APPLICATION NO.	FILING DATE	FIRST NAMED INVENTOR	ATTORNEY DOCKET NO.	CONFIRMATION NO.
10/808,395	03/25/2004	Mutsumi Yano	50024-028	5556
7590	03/25/2005		EXAMINER	
McDERMOTT, WILL & EMERY 600 13th Street, N.W. Washington, DC 20005-3096			THOMAS, ERIC W	
			ART UNIT	PAPER NUMBER
			2831

Office Action Summary

DETAILED ACTION

FIG. 6

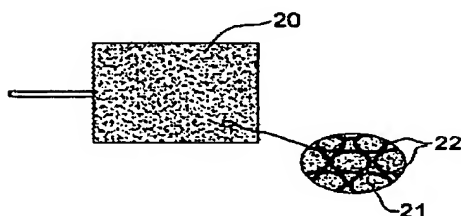
Yoshida et al. disclose in fig. 4, 6, a solid electrolytic capacitor comprising a substrate (13, 21) composed of a porous sinter of niobium particles; a niobium nitride layer (15, 22) formed on the surface of the said niobium particles; and a dielectric layer composed of niobium oxide (upper portion --16) formed on the surface of said niobium nitride layer.
